TE Connectivity

Product Change Notification: P-17-014248

2mm HM connector

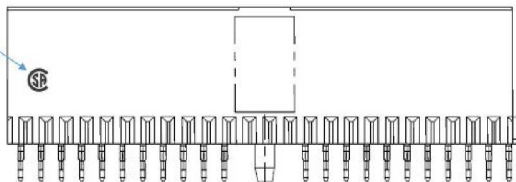
The products will be added a CSA mark on plastic.

CSA mark

CSA mark

Product improvement. 2mm HM connectors had passed CSA (Canadian Standards Association) certification since 1996, but CSA mark was not added on product. CSA request to add CSA mark on each connector.
